December 2, 2015

**ADDENDUM #1
NWIT-15-38
Tenant Improvements
Anvil Centre, New Westminister, BC**

MECHANICAL ADDENDUM

To: City of New Westminster
Email: wwerbovetski@newwestcity.ca
Attention: Wayne Werbovetski
Project: Anvil Centre Dishwashing Room

PART DRAWING OF M-06 GROUND LEVEL DISHWASHING ROOM HVAC

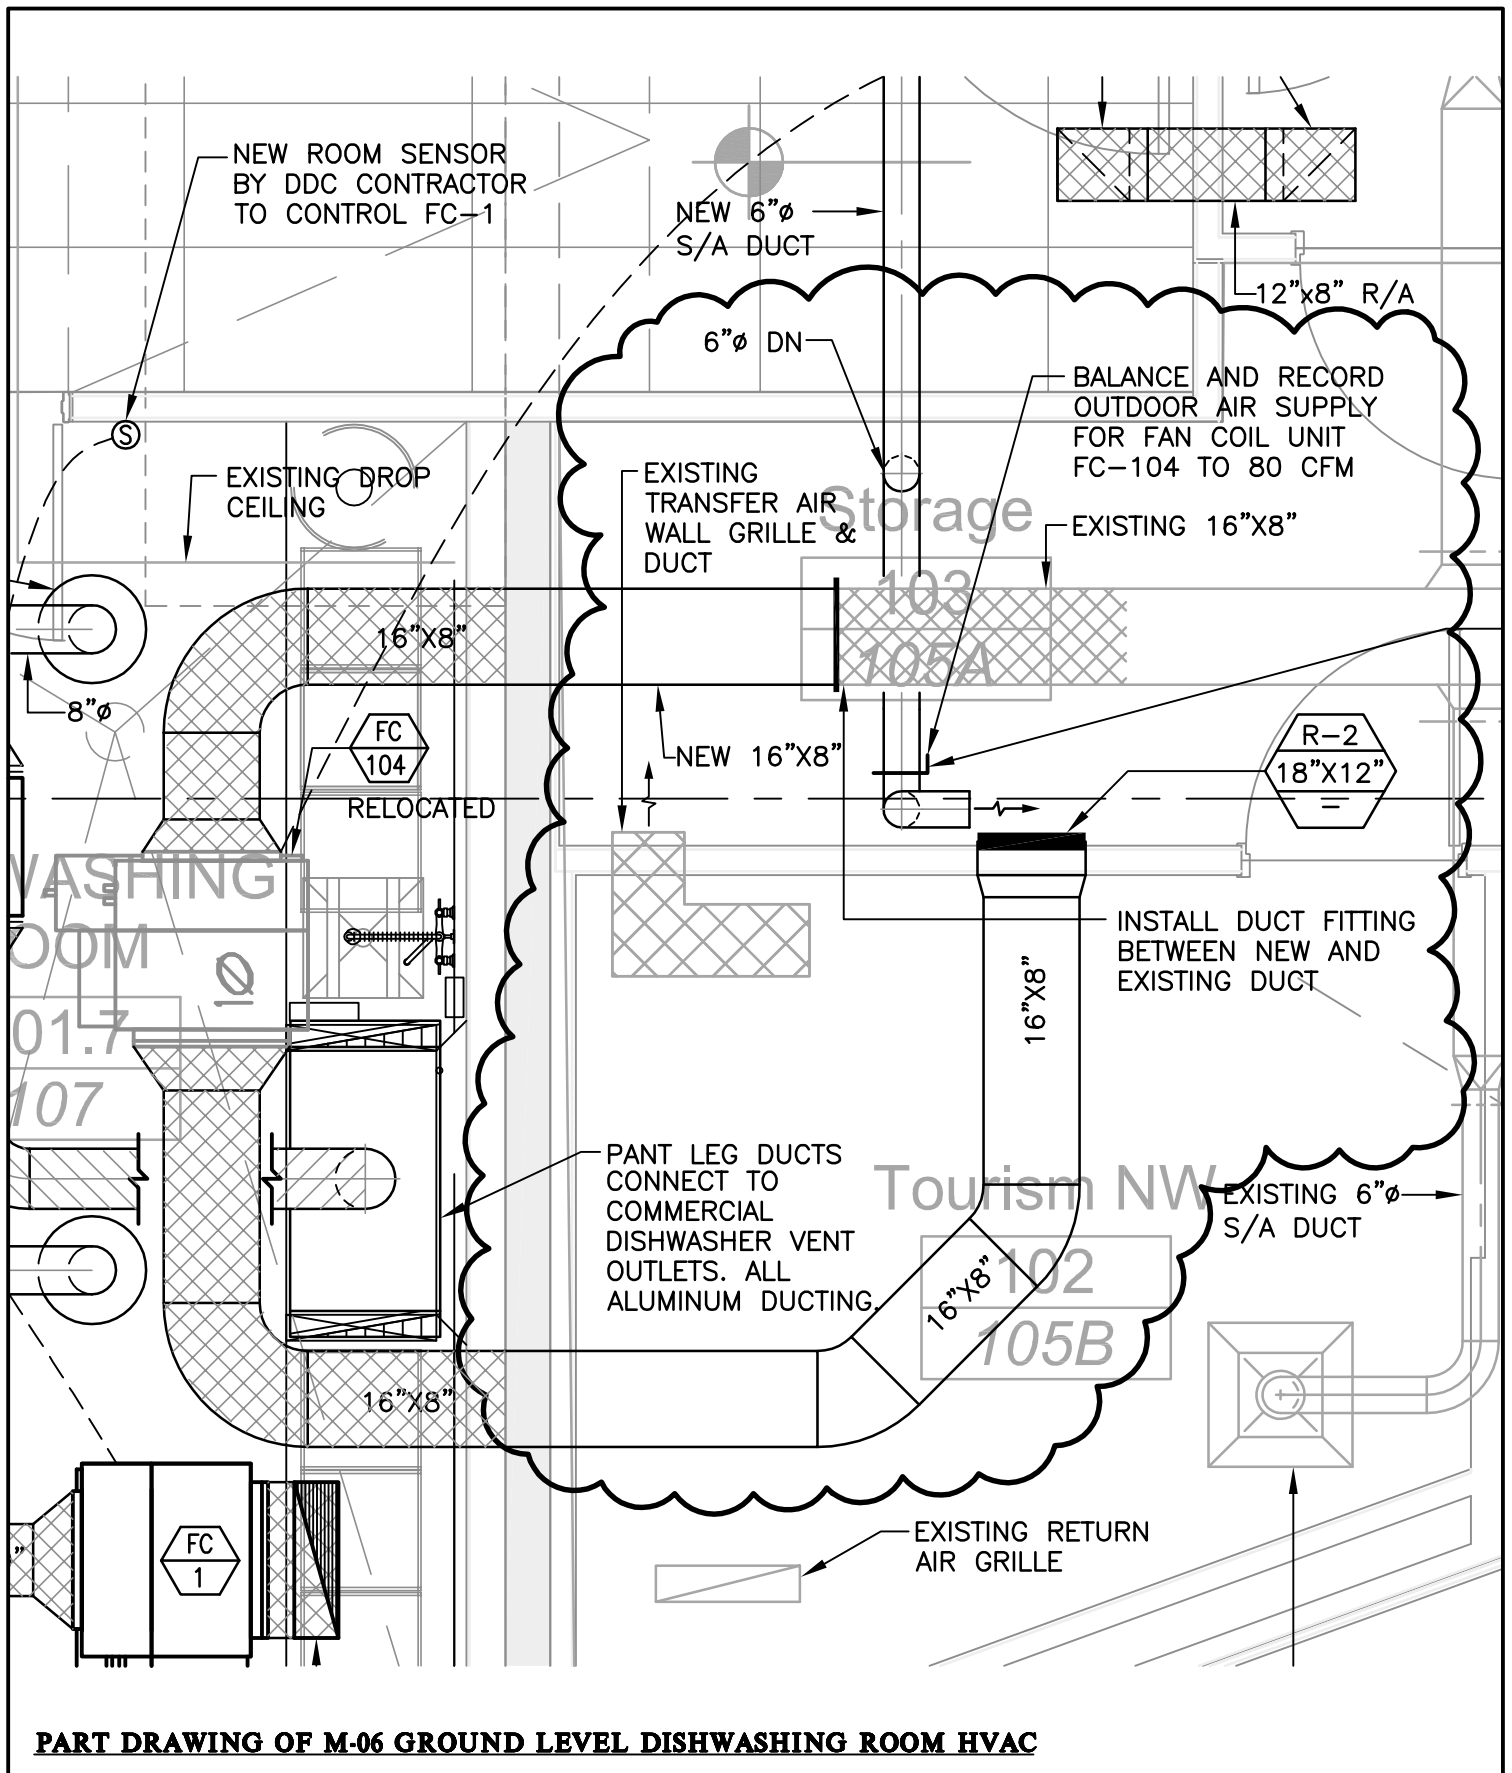
- 1.1 Reference: Drawing M-06
Clarification:
Refer attached sketch MSK-1.1 & MSK-1.2 for revised fan coil FC-104 duct layout.

- 1.2 Reference: Drawing M-06
Contractor shall confirm existing condition above Tourism NW room drop ceiling before installing fan coil FC-104 return air ductwork.

2.1 Reference: Drawing M-02

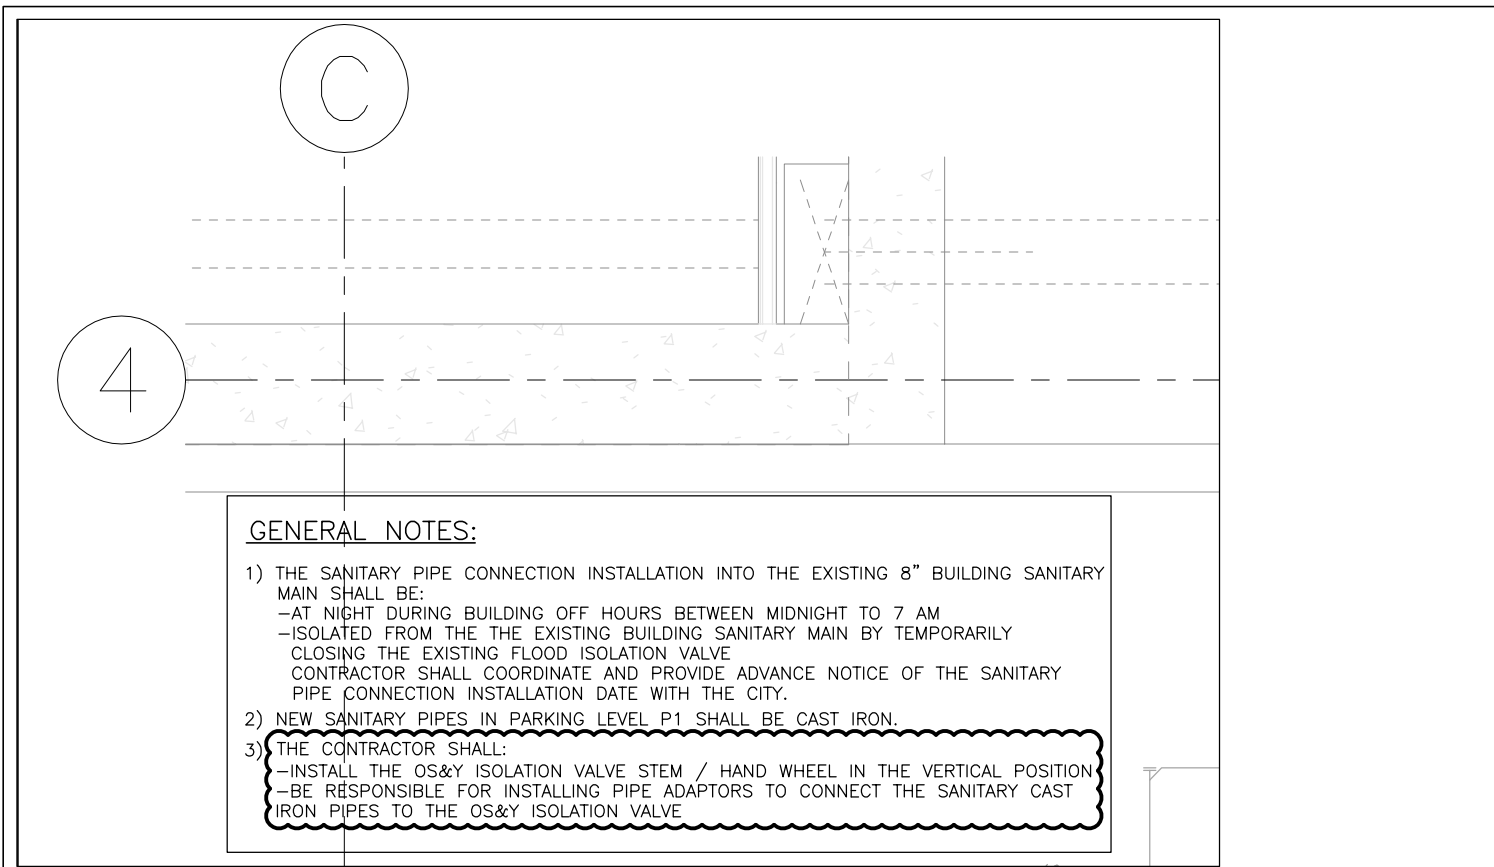
Contractor to install check valve and OS&Y isolation valve (Make: Watts, Model: Series 408-0SYRW), on sanitary connection to main sanitary piping. Install sign on isolation valve to match existing flood isolation valve sign. OS&Y valve to match existing.

Refer attached sketch MSK-2.1 for more information.

PART DRAWING OF M-02 PARKING LEVEL P1

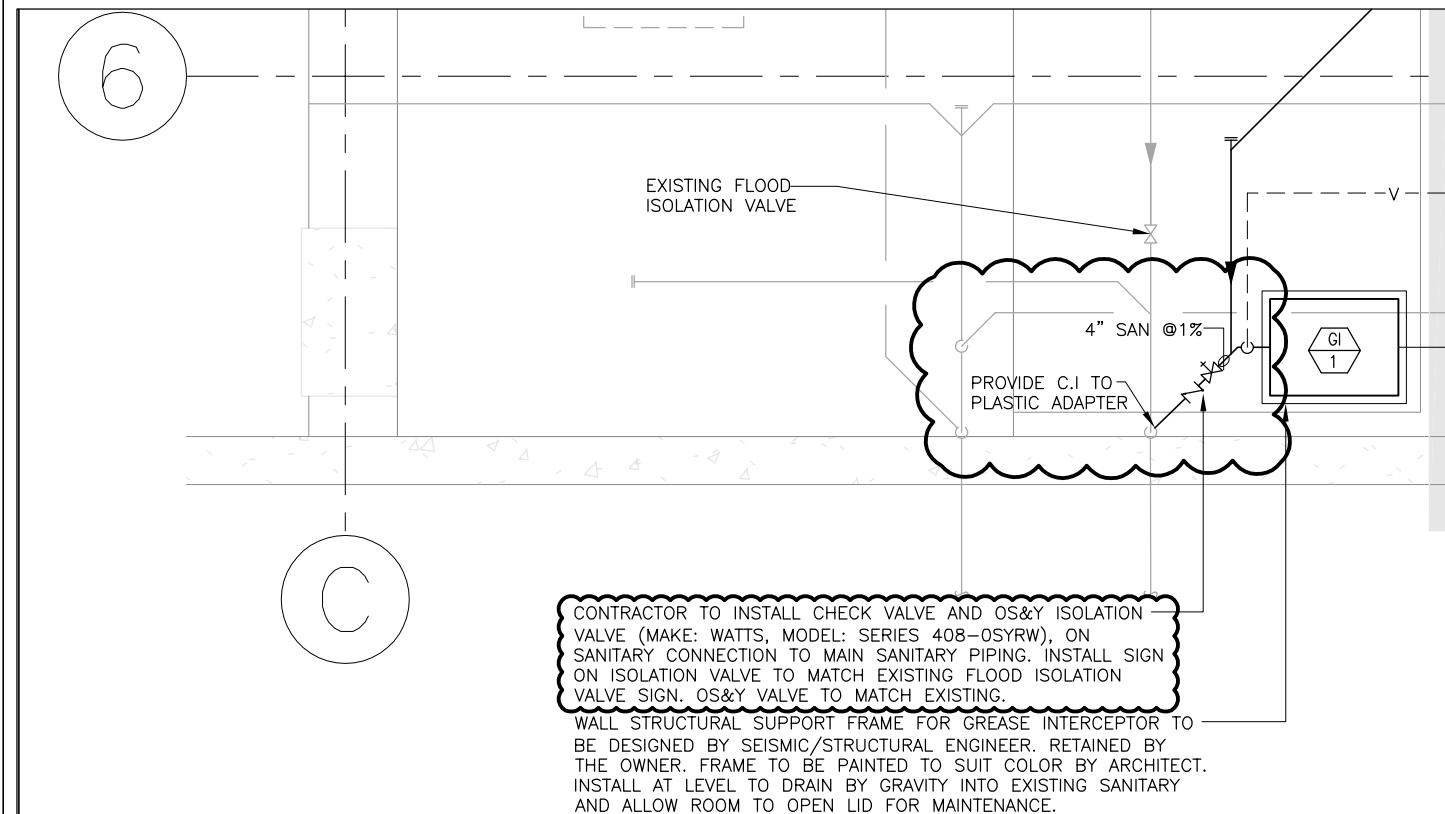
- 1) THE SANITARY PIPE CONNECTION INSTALLATION INTO THE EXISTING 8" BUILDING SANITARY MAIN SHALL BE:
 - AT NIGHT DURING BUILDING OFF HOURS BETWEEN MIDNIGHT TO 7 AM
 - ISOLATED FROM THE THE EXISTING BUILDING SANITARY MAIN BY TEMPORARILY CLOSING THE EXISTING FLOOD ISOLATION VALVE
 - CONTRACTOR SHALL COORDINATE AND PROVIDE ADVANCE NOTICE OF THE SANITARY PIPE CONNECTION INSTALLATION DATE WITH THE CITY.
- 2) NEW SANITARY PIPES IN PARKING LEVEL P1 SHALL BE CAST IRON.
- 3) THE CONTRACTOR SHALL:
 - INSTALL THE OS&Y ISOLATION VALVE STEM / HAND WHEEL IN THE VERTICAL POSITION
 - BE RESPONSIBLE FOR INSTALLING PIPE ADAPTORS TO CONNECT THE SANITARY CAST IRON PIPES TO THE OS&Y ISOLATION VALVE

CONTRACTOR TO INSTALL CHECK VALVE AND OS&Y ISOLATION VALVE (MAKE: WATTS, MODEL: SERIES 408-OSYRW), ON SANITARY CONNECTION TO MAIN SANITARY PIPING. INSTALL SIGN ON ISOLATION VALVE TO MATCH EXISTING FLOOD ISOLATION VALVE SIGN. OS&Y VALVE TO MATCH EXISTING.

WALL STRUCTURAL SUPPORT FRAME FOR GREASE INTERCEPTOR TO BE DESIGNED BY SEISMIC/STRUCTURAL ENGINEER. RETAINED BY THE OWNER. FRAME TO BE PAINTED TO SUIT COLOR BY ARCHITECT. INSTALL AT LEVEL TO DRAIN BY GRAVITY INTO EXISTING SANITARY AND ALLOW ROOM TO OPEN LID FOR MAINTENANCE.
